GRAND GULF NUCLEAR STATION
UNIT 1

RELIEF REQUEST I-00002, REVISION 3

INSERVICE INSPECTION
OF PRESSURE RETAINING WELD IN SCRAM DISCHARGE VOLUME PIPING

GRAND GULF NUCLEAR STATION
INSERVICE INSPECTION
TEN YEAR PROGRAM

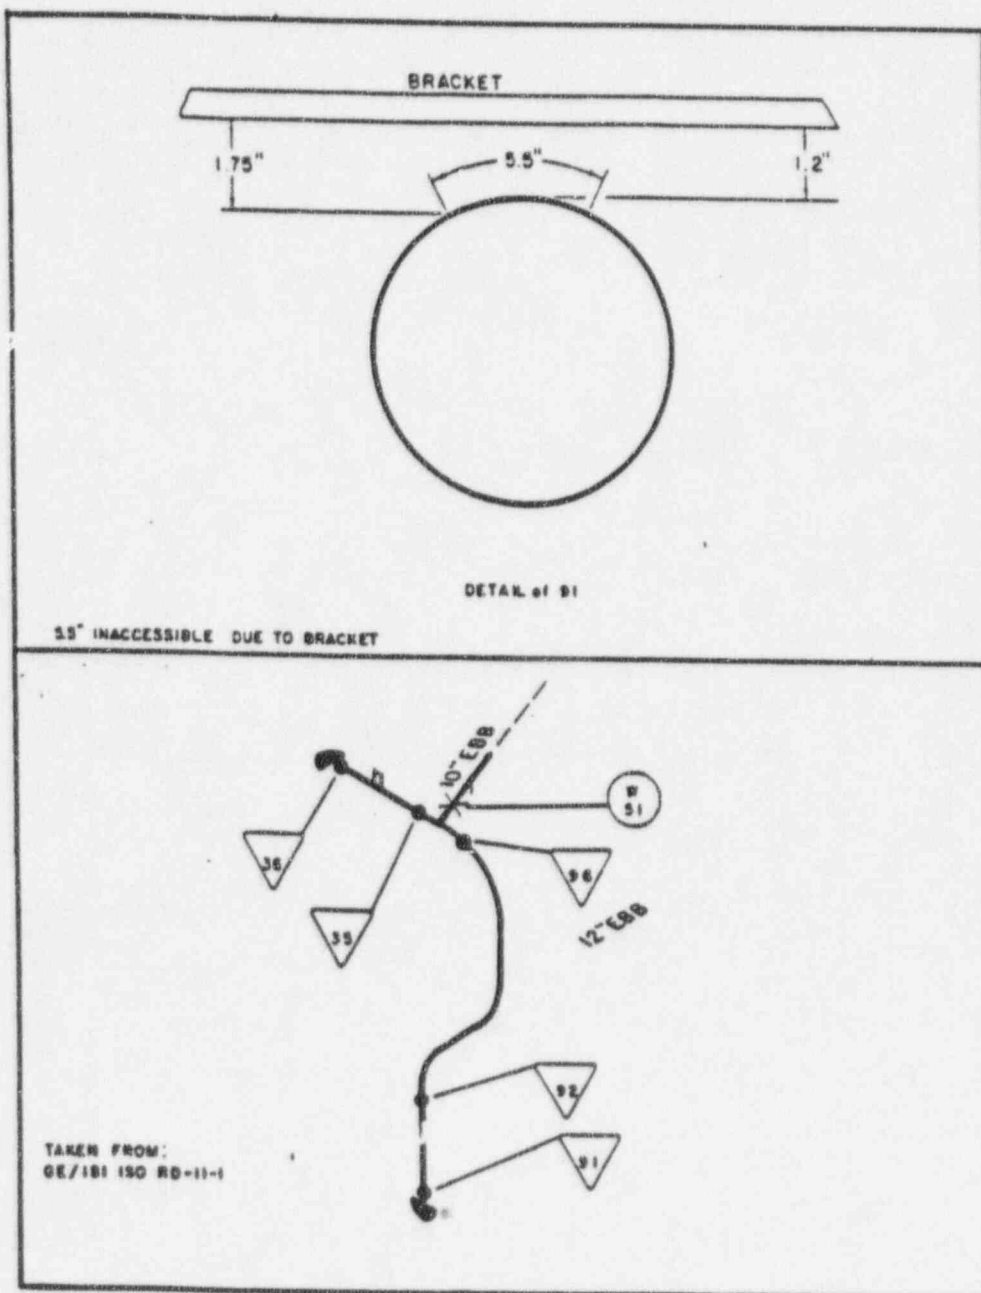
An inaccessible portion of weld No. 91 on the scram discharge volume piping (12" EBB line) is located in the Control Rod Drive Hydraulic (C11) System. (See the attached sketch.)

The installation of a bracket directly above the circumferential weld No. 91 has limited the accessibility to the weld for ultrasonic examination. The inaccessible portion of the weld is approximately 5.5 inches of the circumference of the 12 inch NPS pipe, or 14 percent of the weld length.

Permission is requested to delete the requirement to volumetrically examine the portion of weld No. 91 inaccessible due to the installed bracket.

The accessible portion of the weld will be volumetrically and surface examined each inspection interval in accordance with ASME Section XI, Table IWC-2500-1. Should indications be found, an engineering evaluation will be made to determine if the inaccessible portion of the weld has been affected. The inaccessible portion of this weld represents approximately 14 percent of the total weld length.

FIGURE 1

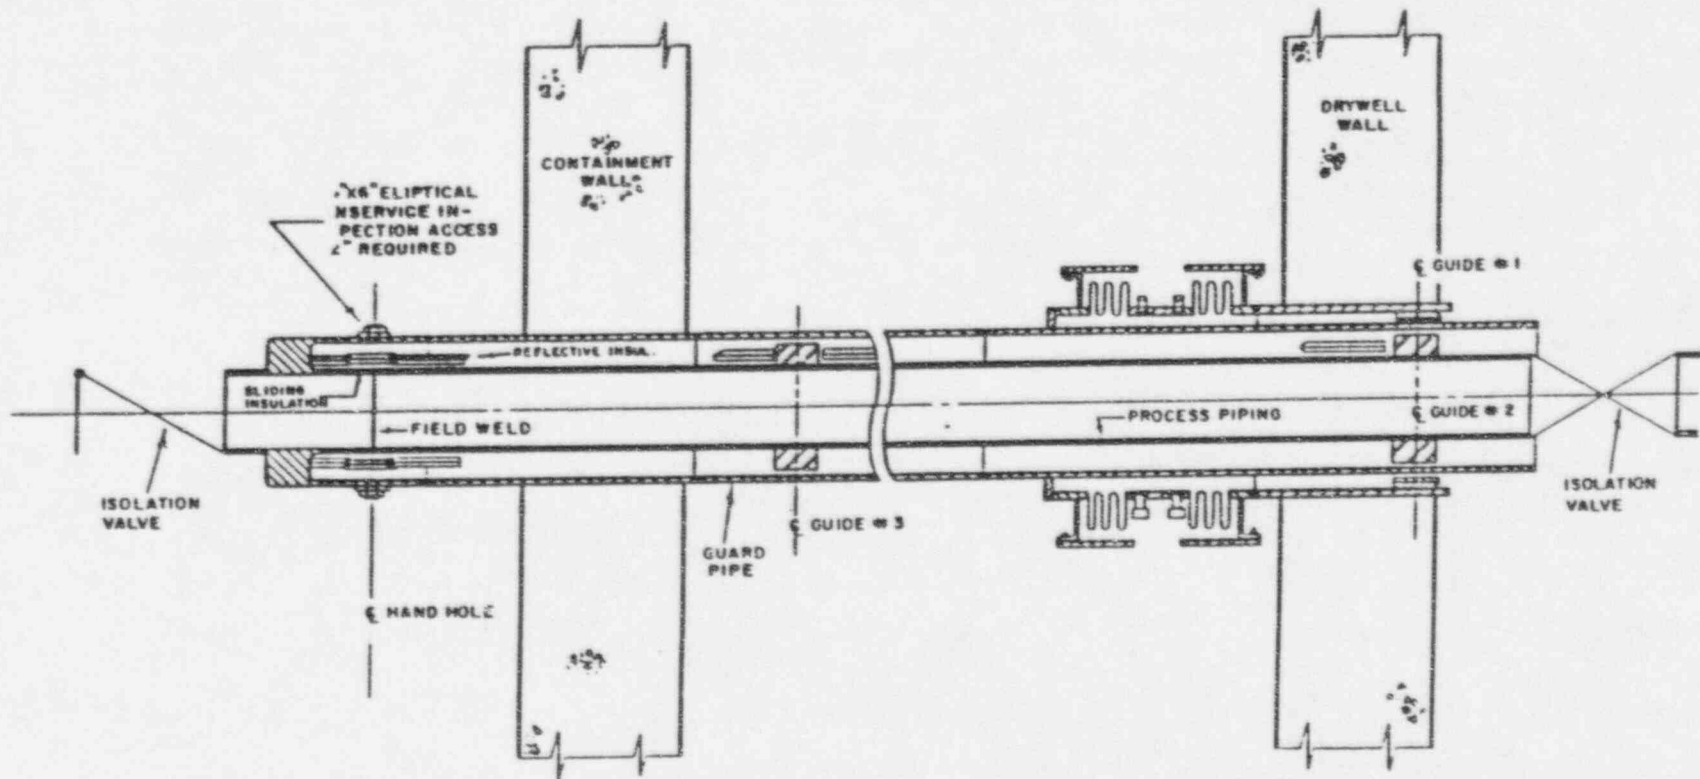
The circumferential welds joining the flued head and the process pipe are encapsulated by the portion of the guard pipe which protrudes beyond the containment. To comply with the inservice inspection requirements of ASME Section XI, two 4" x 6" elliptical access ports spaced 180° apart are provided for access to the welds. During the development of the access port design, the inservice contractor had indicated that the ports were adequate to permit performance of surface and ultrasonic examination of the entire weld.

After fabrication and installation of the process pipe, guard pipe, and flued head, it was determined that the entire length of the weld is not accessible through the two access ports.

Permission is requested to perform ultrasonic examination of the welds listed in Table 1 to the extent possible through the 4" x 6" access ports. Also, permission is requested to perform the code-required surface examinations on the same welds to the extent possible through the access ports. The percentage of each weld examined will be recorded during the inservice examination.

The accessible length of each weld will be ultrasonically and surface examined in accordance with ASME Section XI, Table IWB-2500-1, Examination Category B-J. Should signs of weld deterioration or discrepancies be noted during regular inspections, evaluation of the conditions will be made.

FIGURE 1

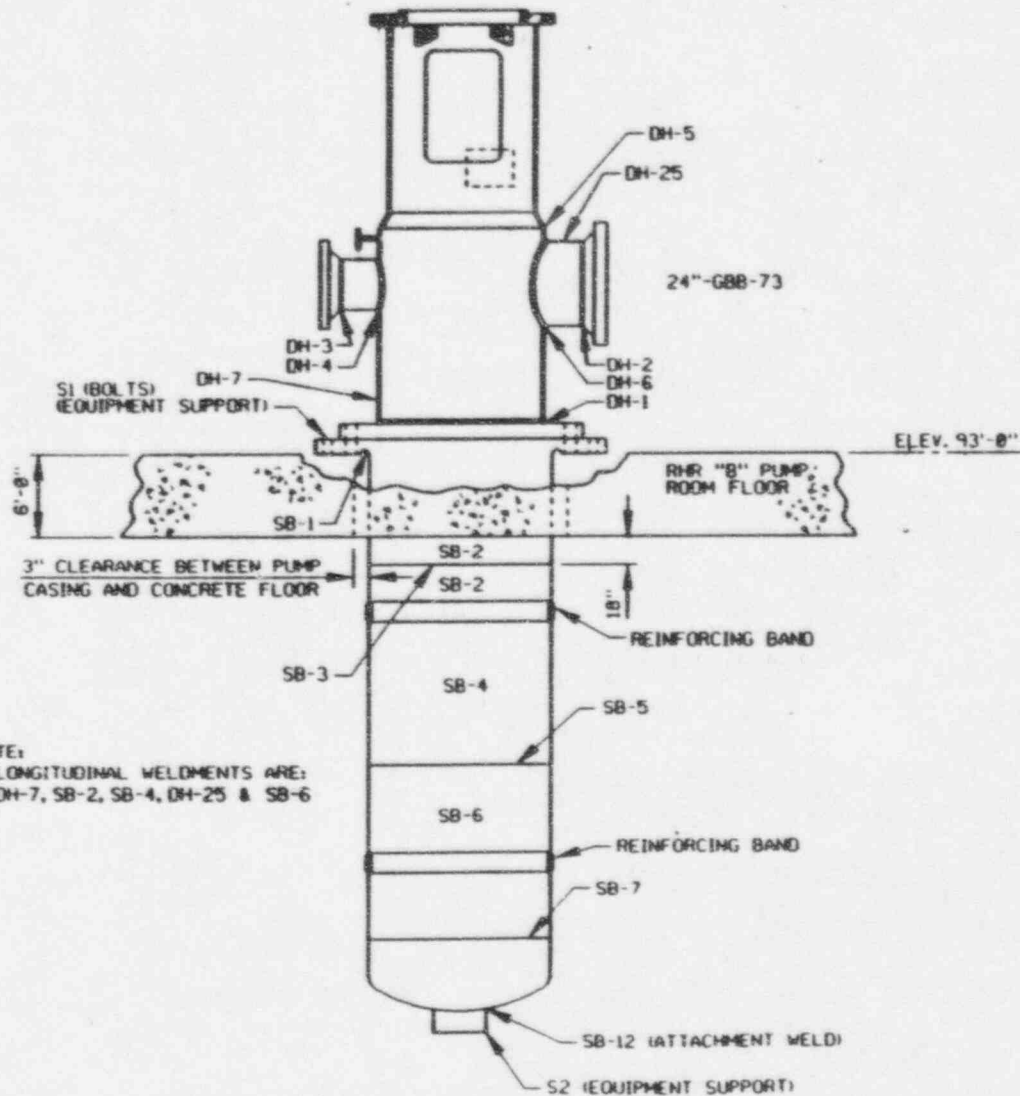
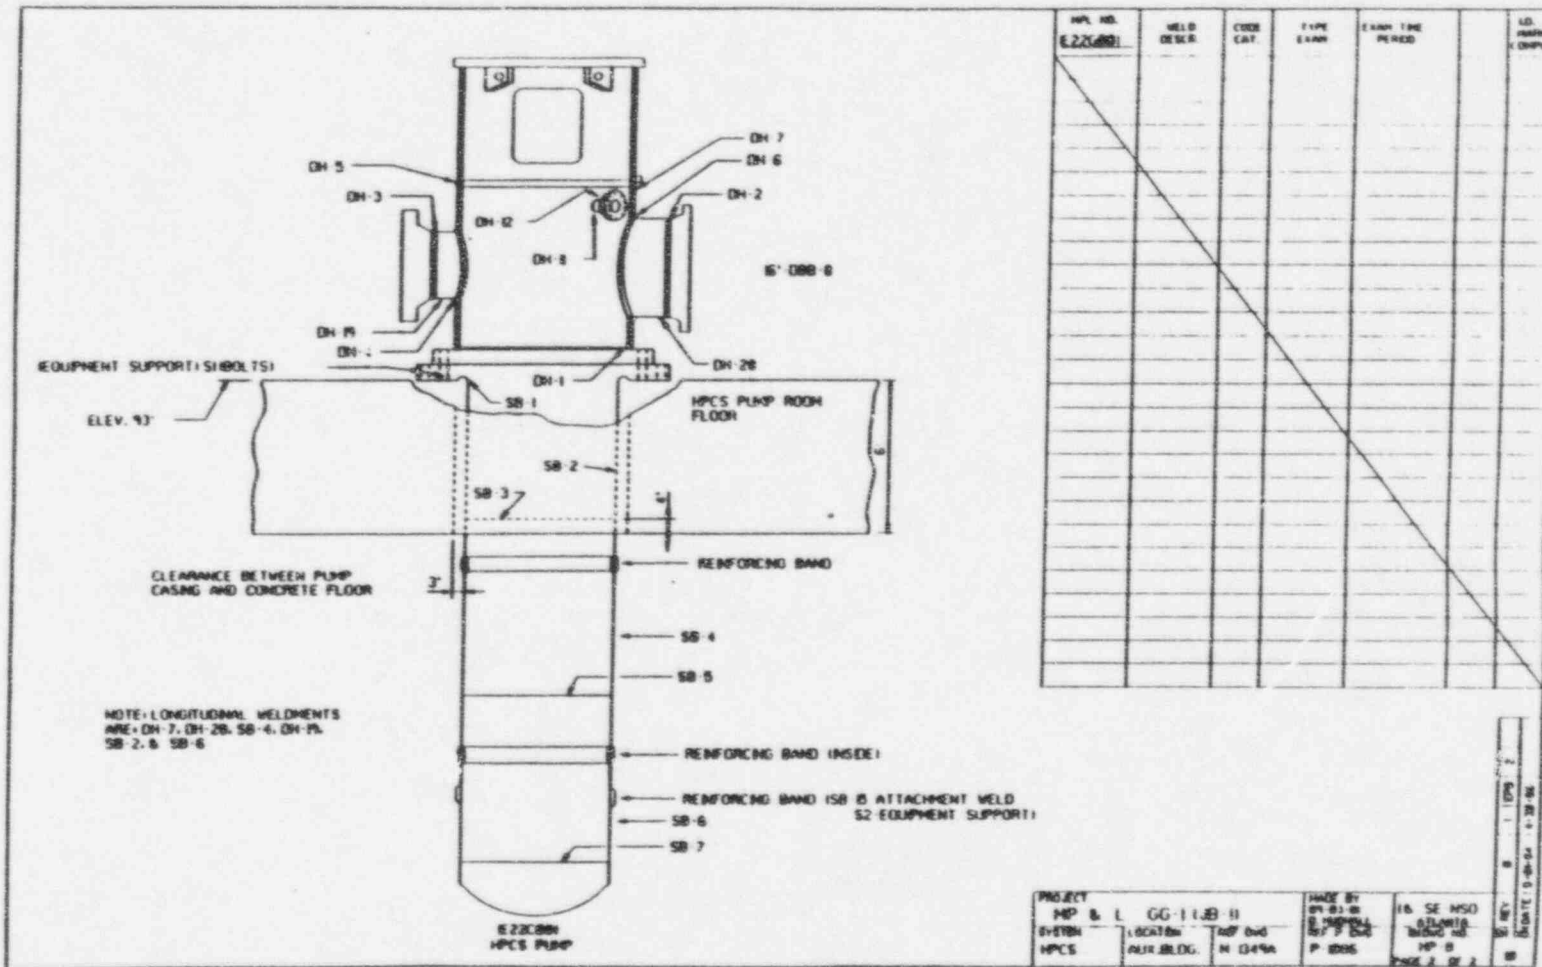
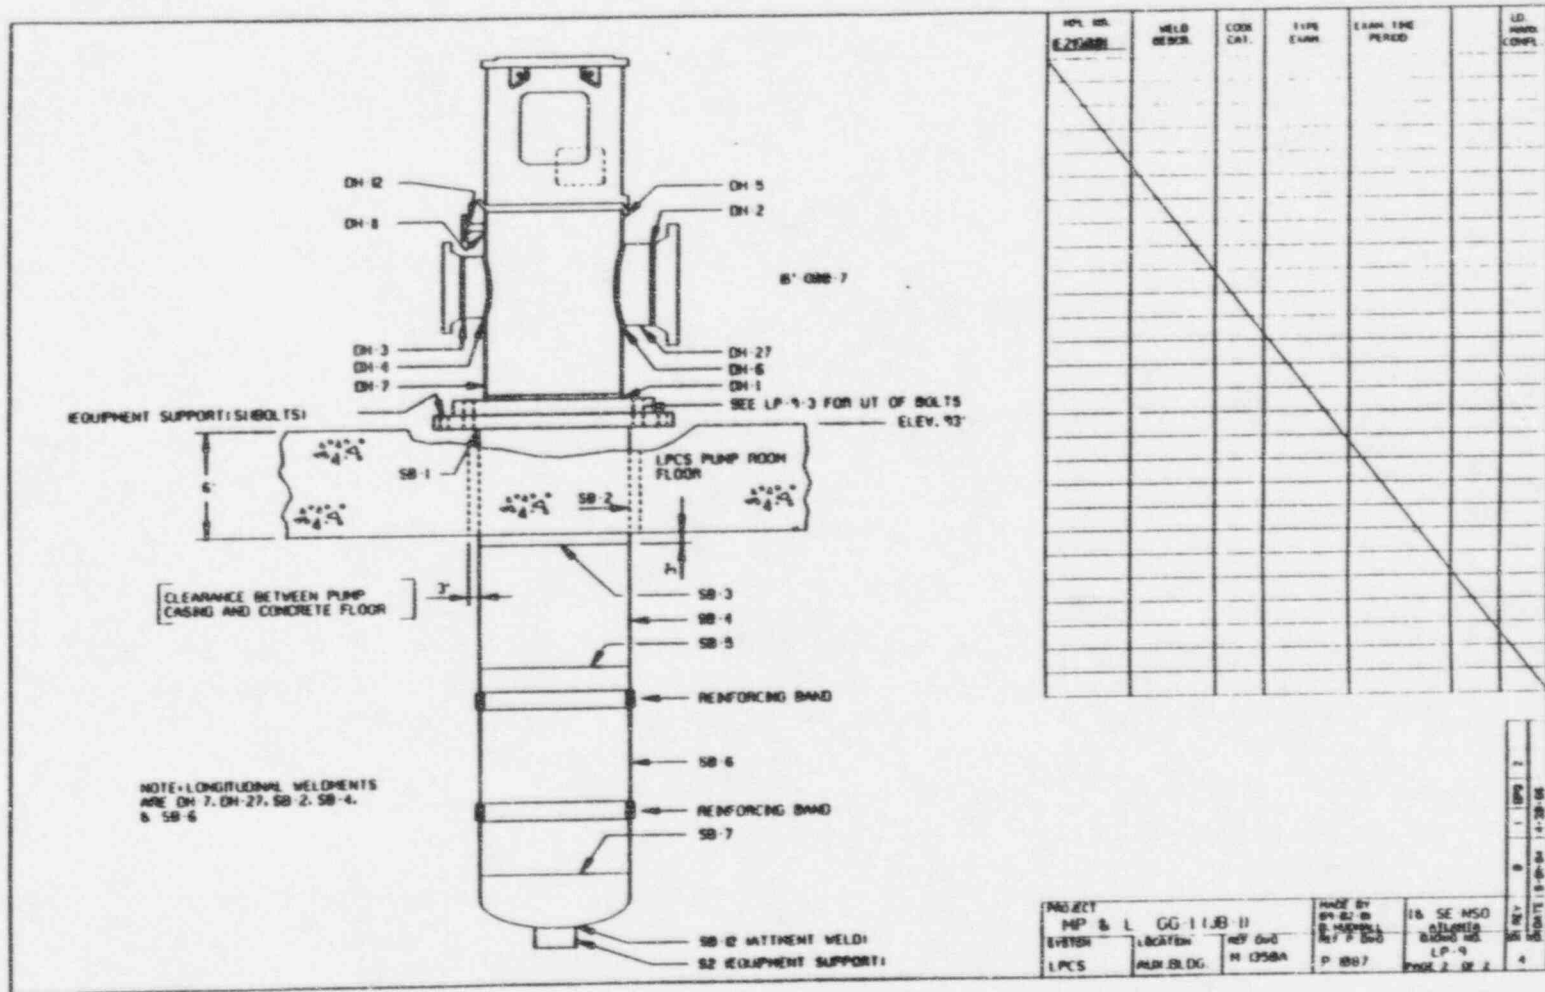
Inaccessible pump casing welds are located where the concrete pump support encasement only allows a 3 inch clearance between the pump casing and the concrete encasement wall (see figure 1 for details of the design). Due to the limited accessibility, it is impractical to surface examine those portions of the welds located within the surrounding concrete pump support encasement. The 1E12C002B and 1E21C001 pumps also have a support integrally welded to the bottom exterior of the pump barrel that rests against the sump floor. The clearance between the floor and the bottom of the barrel is approximately 1 inch preventing sufficient access to perform the surface examination of the 1/2 inch of base material on each side of the attaching weld (see figure 2).

FIGURE 2

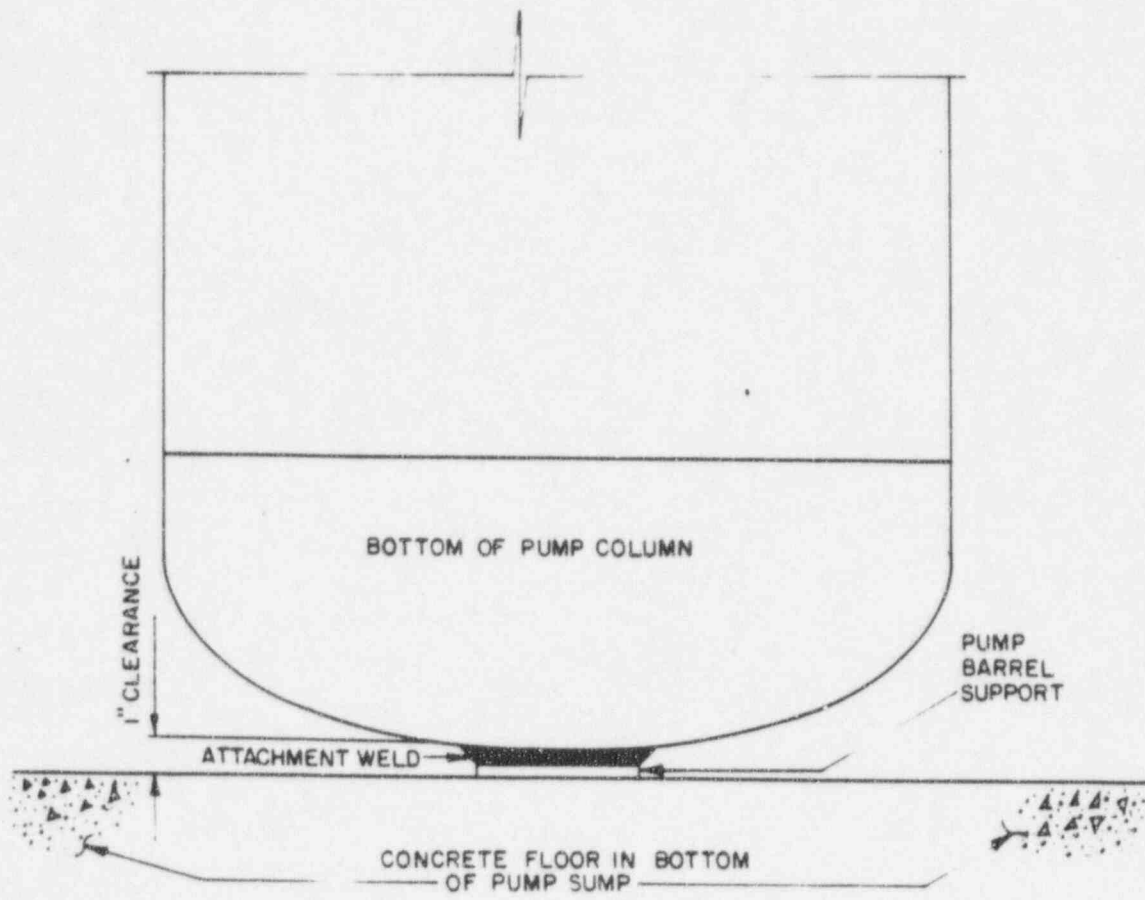
Permission is requested to exempt from inservice inspection the inaccessible portions of the pump casing welds listed on Table 1. Also permission is requested to exempt the base material associated with the support attachment welds from the surface examinations as shown in figure 2.
